Submission to Draft Amendment C295 to the Casey Planning Scheme - Casey Fields South (Employment) and Devon Meadows Precinct Structure Plan (PSP)

Submission to draft Amendment C295 - Casey Planning Scheme

Casey Fields South (Employment) and Devon Meadows
Precinct Structure Plan

Figure 4 - Updated Plan 6 (Water) – MAB properties

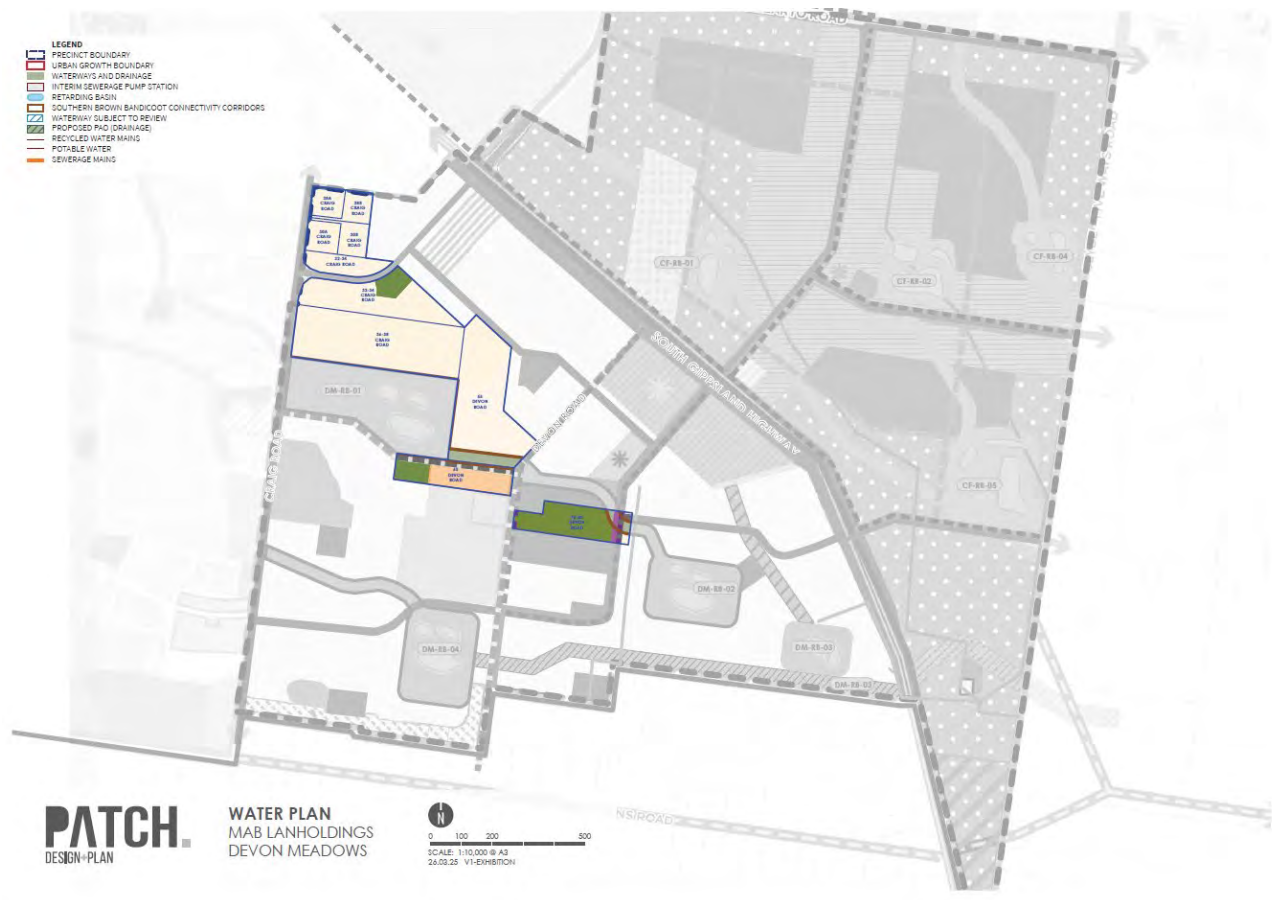
Figures 3 and 4 highlight the consolidated suite of changes to Plan 6 (Water) and specifically MAB's land for further consideration and agreement with the VPA and Melbourne Water.

Prior to public consultation of the PSP, MAB highlighted to the VPA and MWC through engineering-led meetings that the proposed constructed waterway in the north-western part of the DMPSP is not required to convey the low volumes of stormwater flows from Junction Village and that it should be removed to enable an improved urban structure. This change will also increase the net developable area of the PSP which in turn will increase the PSP yield and increase the ICP levies available to Council from the standard levy.

Figure 5 – Updated Plan 9 (Infrastructure and Development Staging)

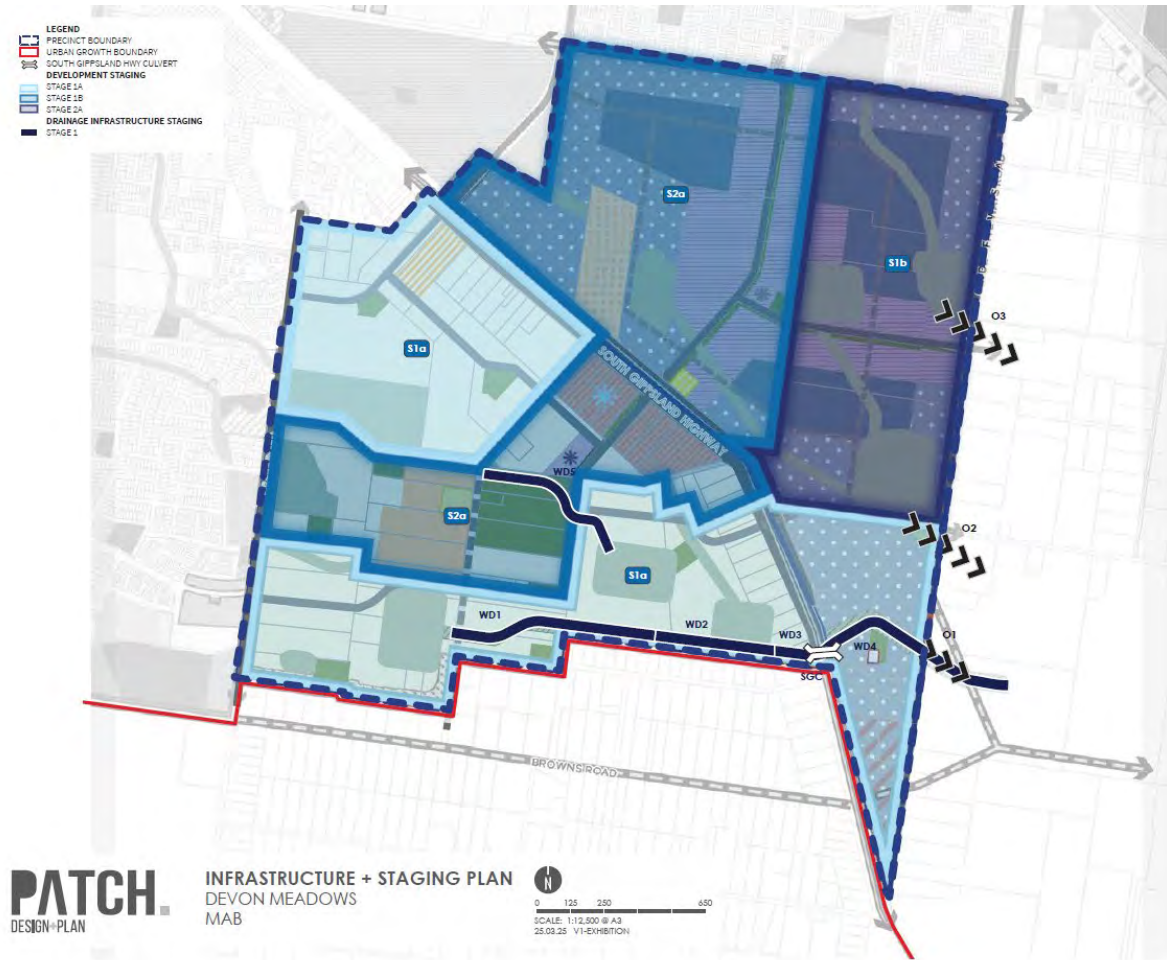
Plan 9 of the DMPSP should be amended (refer to **Figure 5** below) to reflect MAB’s alternative drainage scheme as:

- It leverages the use of the existing and underutilised MWC land for drainage purposes by “unlocking” the area of land in S1A shown in Figure 5 for immediate urban development; and
- The northern section of MAB’s revised S1A is not reliant on the acquisition of land for WD1-WD4 or the South Gippsland Culvert identified in Plan 9 in the southern portion of the PSP and only requires the necessary works to construct a wetland / retention basin in line with MWC DSS requirements.

Figure 6 – Active Open Space Template (VPA)

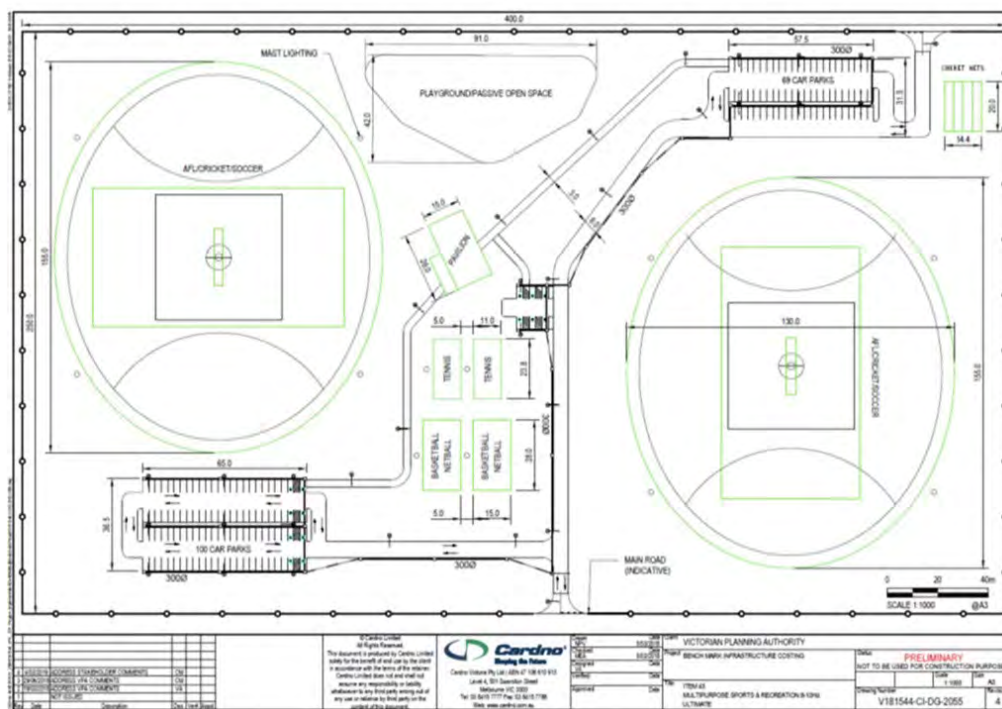
The VPA’s Benchmark Costing Report provides the template shown in **Figure 6** below depicts the typical build out of an active recreation reserve. Space is at a premium and the facilities have certain functional requirements and location synergies that the exhibited VPA recreation reserve concept is not able to provide.

Figure 8 - Updated Active Open Space

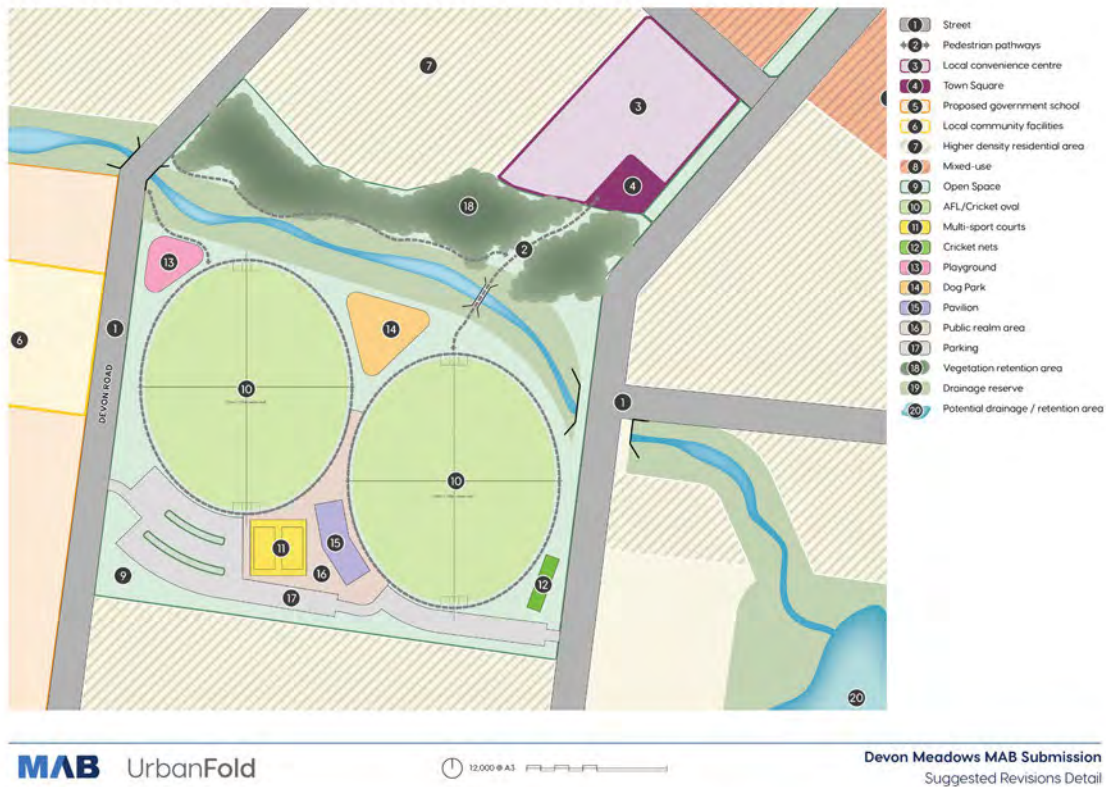
Figures 7 and 8 below depict MAB’s revised layout of the Active Open Space as a result of the re-alignment of the constructed waterway. Two senior AFL ovals have been shown; however, the same

principle would apply to the delivery of soccer facilities on the reserve. The relocated waterway provides greater flexibility for the delivery of soccer facilities.

Figure 1 – Draft PSP Place Based Plan (VPA)

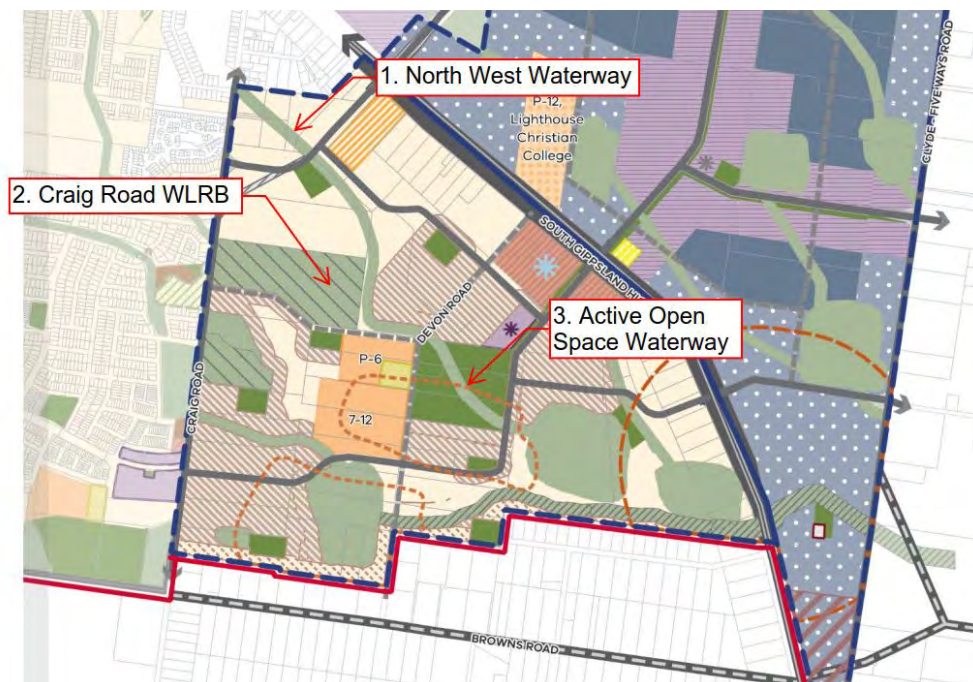
- 3. The proposed constructed waterway through the Active Open Space east of Devon Road shown on Plan 2 (Place Based Plan) of the PSP can be realigned to the north and east, providing improved usability of this important community asset whilst incorporating existing vegetation identified for retention in the PSP supporting habitat for the Eastern Brown Bandicoot and providing mature vegetation within the new urban area.**

Figure 19 – Sketch layout as shown in the draft PSP

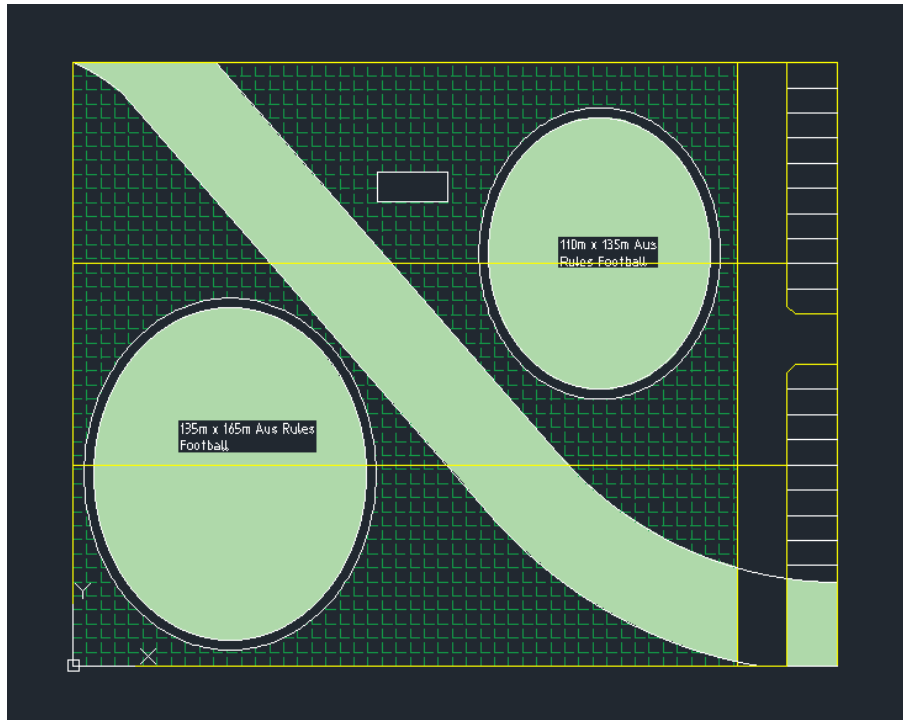
A high-level analysis has been undertaken on the Active Open Space Area and how it would be impacted by the proposed constructed waterway which bisects the area, significantly limiting the usability of the facilities.

Given the constraints placed on the sports facilities by the proposed diagonal waterway, an alternative waterway alignment and configuration of the AoS is provided below in **Figure 20**.

Figure 2. MW-GHD Predeveloped conditions RORB Model

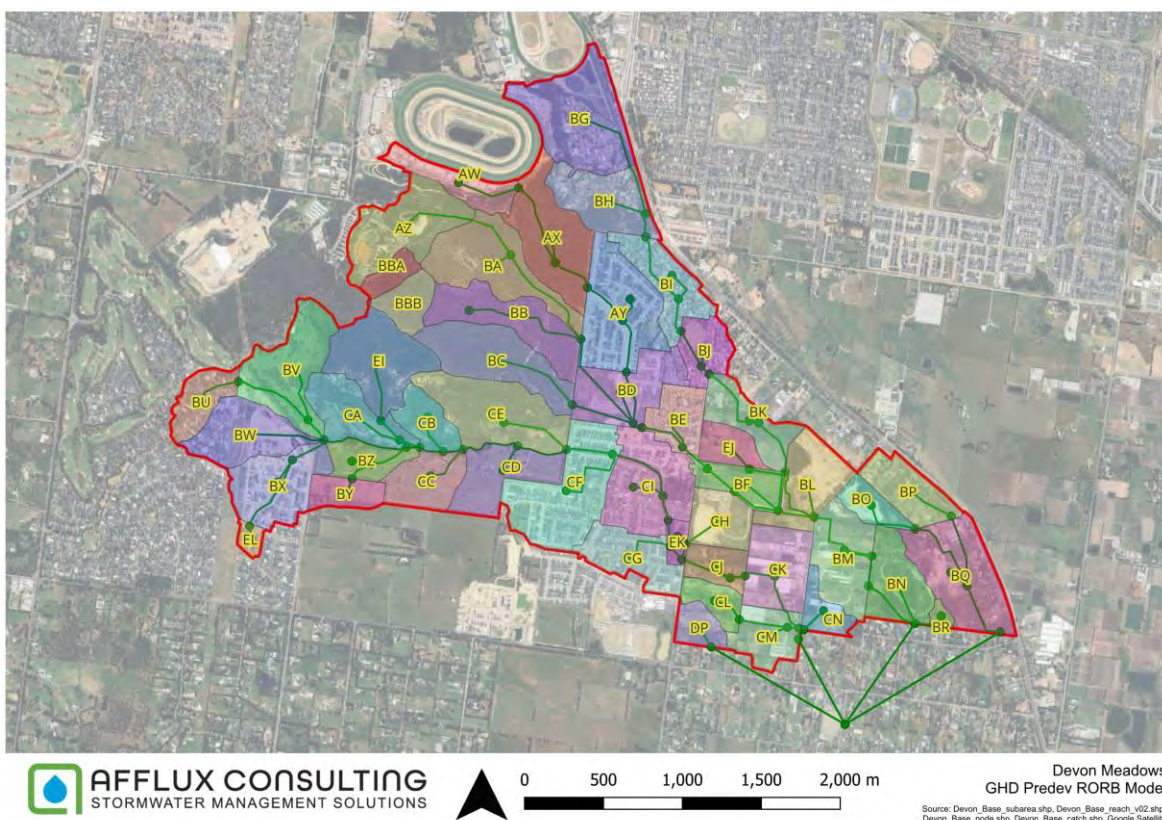
A discrepancy in the Kc value for pre-developed conditions was noted between the MW-GHD report (2.94) and the provided RORB .par file value (3.74). Upon testing these values, it was found that the lower Kc produces more conservative results. This prompted the decision to use Kc = 2.94 for this purpose. Meanwhile, the post-development Kc value is considerably higher at 3.93, which results in significantly reduced flows. Therefore, the pre-development flows were maintained for use in the post-development conditions, as they provide a more conservative assessment.

It is suggested that an interstation area at the PSP interface may help with this issue, but would also result in a more complex model.

Figure 3. MW-GHD Post-developed conditions RORB Model

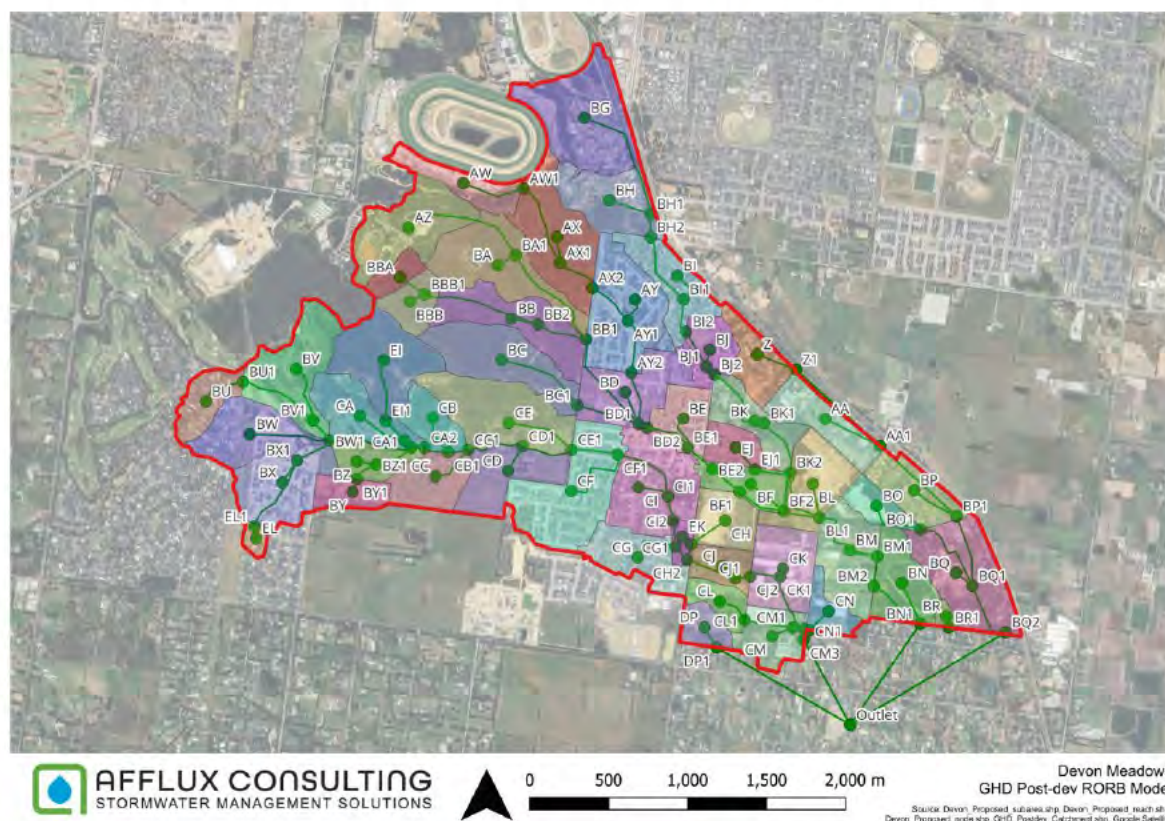
The flows as supplied from Melbourne Water are listed in Table 2: A number of items are noted from these flows:

- It is noted that the existing conditions flow is listed as 5.4m³/s well below the hydraulic width requiring a waterway (typically the industry standards for a waterway hydraulic width is around 10m³/s). It is wondered why we are discussing a waterway for this level of flow in a location with no existing waterway layer.
- The Croskel PSP used a climate change scenario of SSP2. The SSP5 scenario is an extreme scenario, and is not recommended for use for design of assets by the federal government guidance documents. It is acceptable as a extreme scenario check.
- The Developed conditions Kc used for the sizing of downstream assets has a much lower flow than the existing conditions. This is largely a schematisation issue with the model.

- It is noted that we had difficulty matching the flow data in the report using the supplied loss models and design rainfall. We suspect that the changes are in the application of the loss models. We have adopted similar flows (with minor changes to TC and TP) to match the reported flows and stay conservative.
